# OCE006 - Anticipate Spare parts shortage

Kit to replace Gearboxes KA39 with WA47 on inlet dosing belt two way

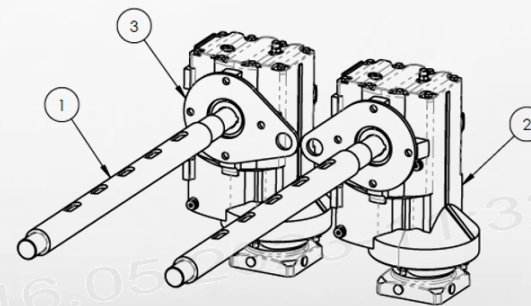
- Safer solution with newer component available in the market.
- Can prevent long downtimes in case of failure
- SEW gearboxes KA39 are phased out by manufacturer.
- Spare Part unavailability.
- Risk of long Downtime for equipment at Bottlers prod plants as it takes an upgrade to be able to install active newer components.

- New system with gearboxes SEW WA47:
  - The new system consists of gearboxes WA47 with similar reduction ratio, replacing the obsolete ones.
  - Available in case of brushless and asynchronous motors (Motors can be recovered only if brushless)
  - It includes adaptation kit
